**ADDITIONAL DETERMINISTIC EVALUATIONS
PERFORMED TO ASSESS SEISMIC MARGINS
OF THE DIABLO CANYON POWER PLANT
UNITS 1 AND 2**

Diablo Canyon Power Plant
Long Term Seismic Program

PREFACE

PG&E's response to the NRC Staff's April 1990 request for additional information regarding the Diablo Canyon Long Term Seismic Program deterministic evaluations is contained in this volume. The reply to the request is included in the responses to nine questions we have formulated to best describe the additional deterministic evaluations performed to augment the information contained in Chapters 7 and 8 of the Long Term Seismic Program Final Report. The NRC Staff's general request precedes Question DE 1.

Figure DE Q7-1

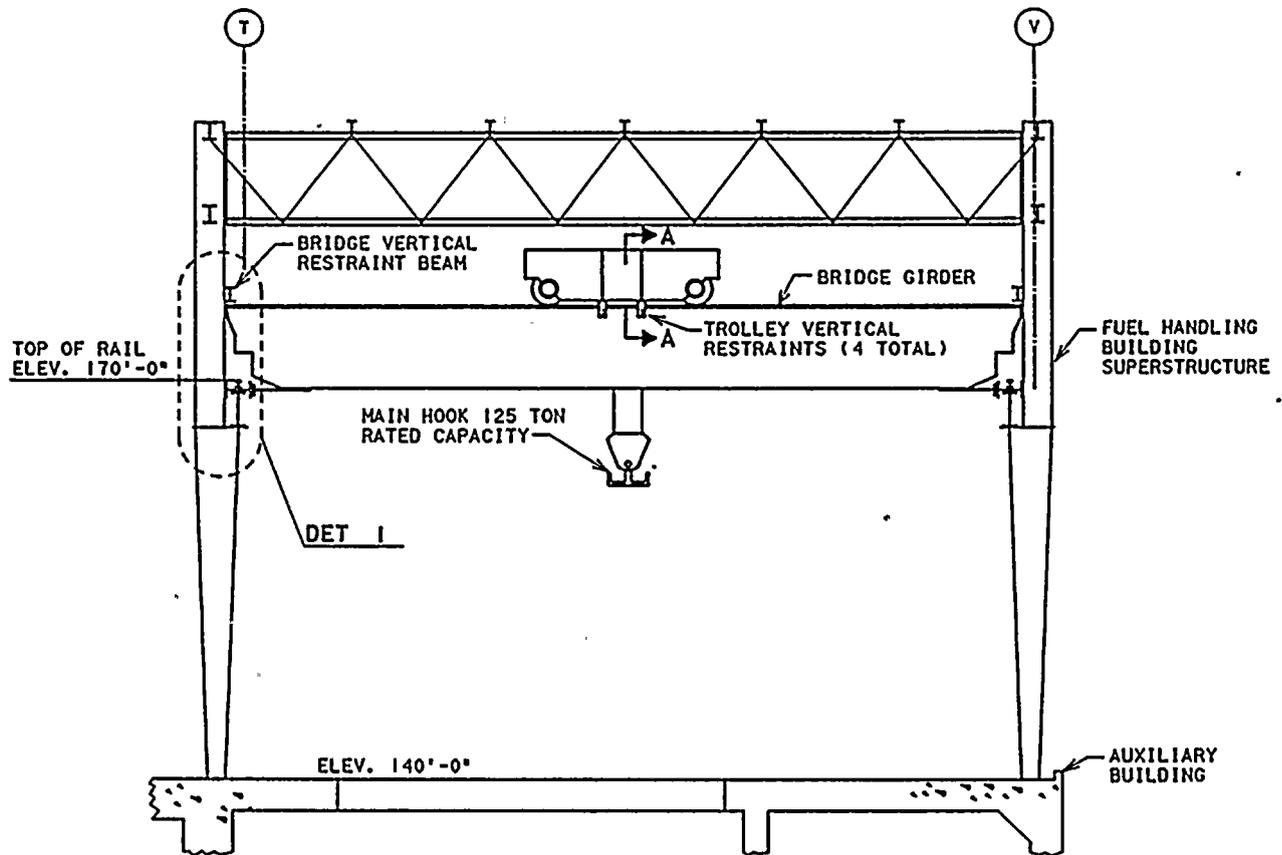
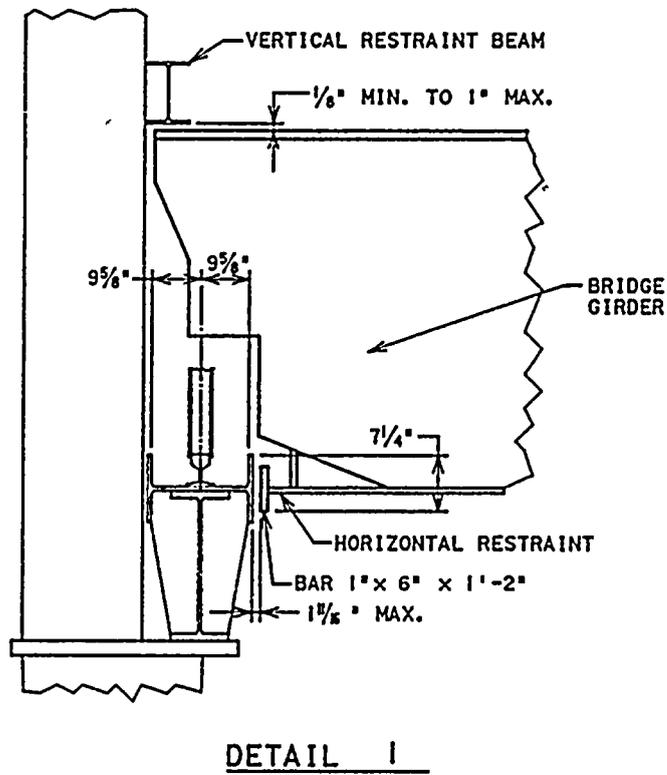
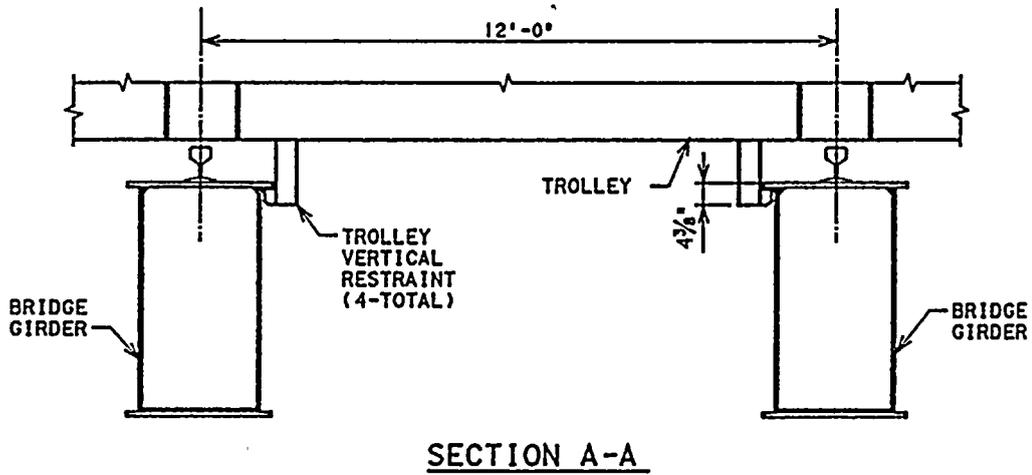
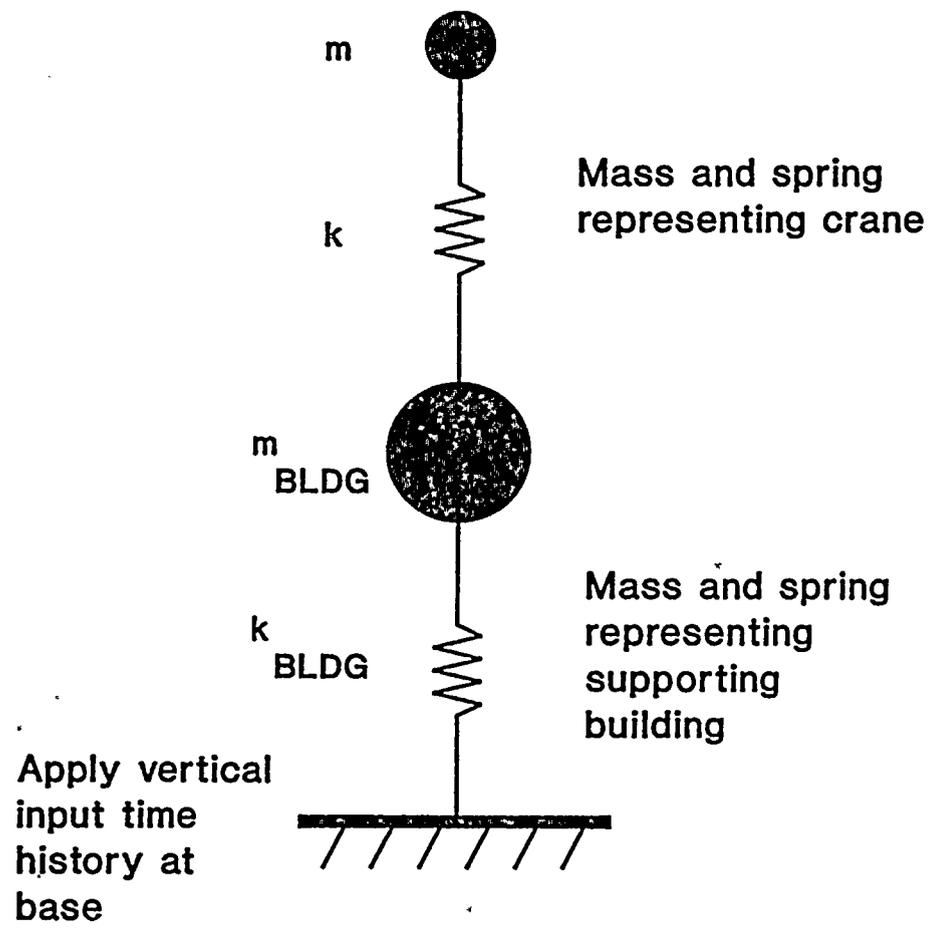
QUESTION DE 7

The fuel handling building crane is an electric overhead travelling crane serving both Units 1 and 2 with a rated lift capacity of 125 tons. The crane is housed in the fuel handling building steel superstructure. An elevation of the crane is shown in Figure DE Q7-1. The crane consists of two welded box-type steel bridge girders spanning between runway girders and supported on the building superstructure columns. A trolley is mounted on top of the bridge girders.

Restraints are provided to inhibit vertical movement and to prevent derailing of the bridge and the trolley from their rails. Details of the trolley and bridge girder restraints are shown in Figure DE Q7-2. Bridge derailment is prevented by horizontal beams located above the ends of the bridge. The beams are bolted to the building columns. Trolley derailment is prevented by four brackets attached to the trolley and extending under the bridge girder top flanges. Horizontal restraint bumpers are provided to transfer transverse loads from the crane bridge girders to the crane runway girders.

The simplified method of calculating demand KE was validated by performing a linear elastic time-history analysis of a simplified model of the crane and computing the total energy of the system at each time step. A simplified model of the crane system consisting of two masses and two springs representing the crane and the supporting building structure was used. The model is shown in Figure DE Q7-3. The following equation was used:

The uplift capacity was calculated from the uplift height at failure (Δ_u). As shown in Figure DE Q7-2, the crane must uplift at least 7-1/4 inches before lateral restraint provided by the horizontal bumpers could be lost. Even at such a height, the supporting building structure must displace laterally more than 9 inches relative to the crane before the crane could fall from the runway girder. An uplift height of 4.75 inches was conservatively chosen as a HCLPF value. The energy capacity is also composed of the contribution from the bridge vertical restraint beam, but this contribution is somewhat less than the potential energy of the crane. The uplift capacity, C, was defined by:

Figure DE Q8-1

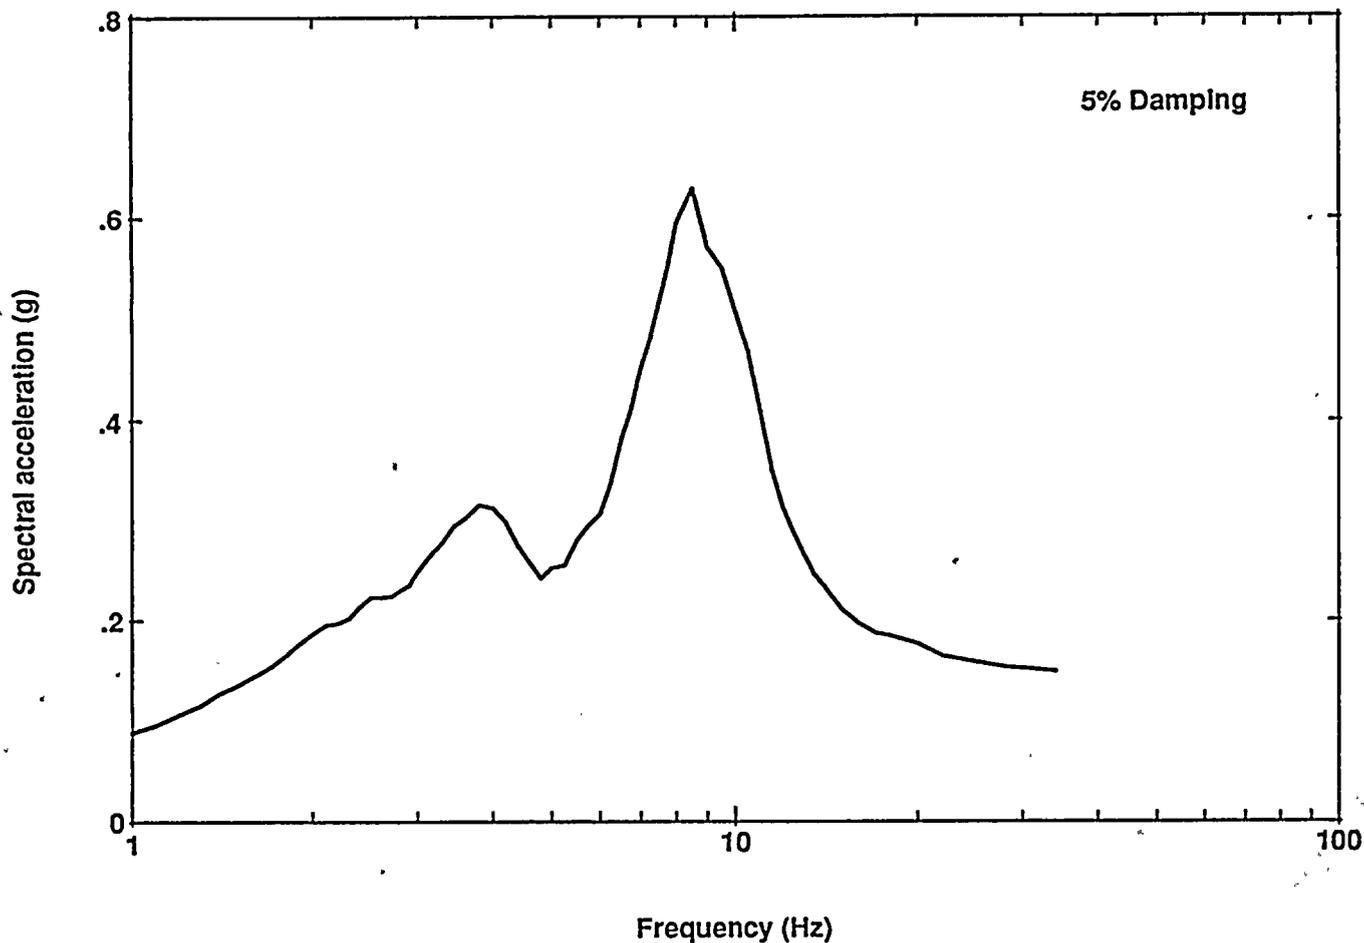
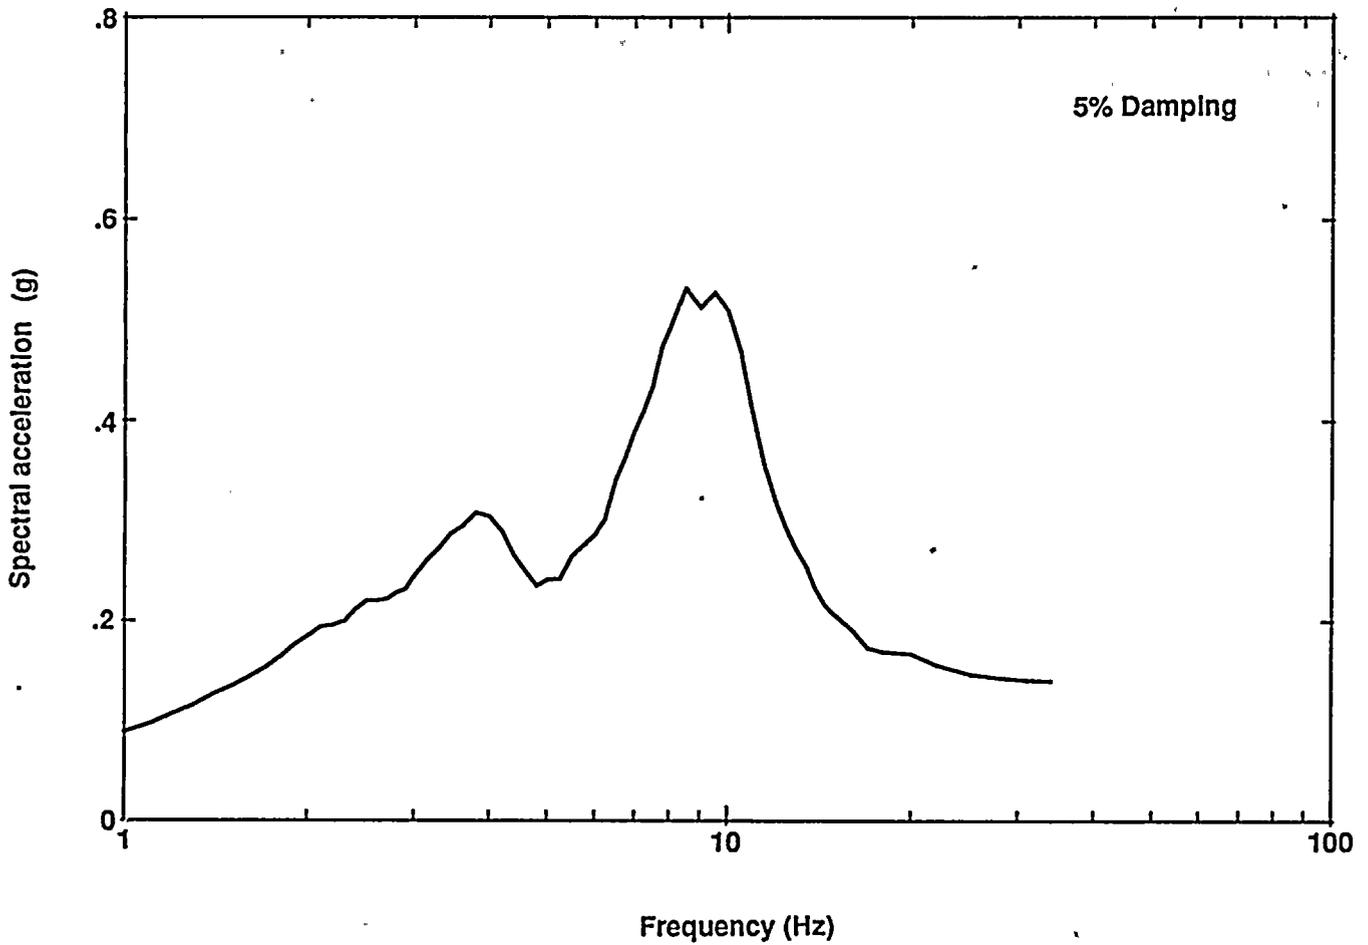
QUESTION DE 8

The containment internal structure north-south and east-west floor response spectra at elevation 140 feet (Figure DE Q8-1 and Figure DE Q8-2) resulting from the 84th-percentile, site-specific ground motion due to maximum magnitude earthquake was used to determine the demand loads. The analysis accounted for the effects of soil-structure interaction but did not include the effects of ground motion incoherency. In contrast, the demand load from the vertical excitation was determined by scaling the Hosgri vertical floor spectrum at elevation 140 feet by the ratio of maximum magnitude earthquake vertical ground response to the Hosgri vertical ground response at the floor slab frequency. However, the contribution from the vertical excitation was small and the stress in the weld was dominated by the horizontal seismic input plus the piping loads.
